Technical Bulletin- Unbalance Vent Addendum

King Heating Products Inc., has a request to clarify section 5.59.1. Below in italics is what is mentioned in our current installation manual regarding unbalanced terminations.

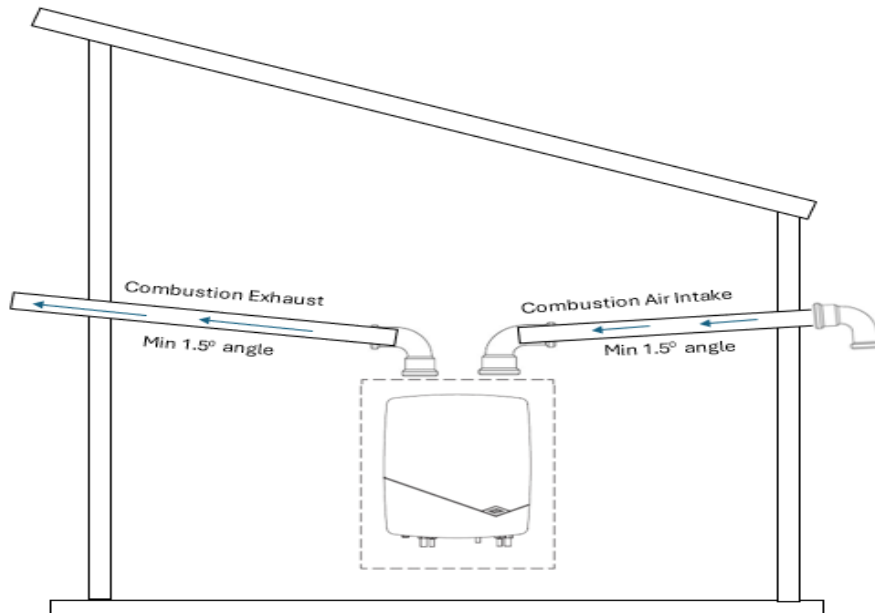
The section mentions that exhaust and intake venting can be used with a vertical roof penetration and simultaneously a horizontal side wall penetration.

This addendum certifies that using two opposite horizontal pressure zones is permitted as well. See below picture as one example:
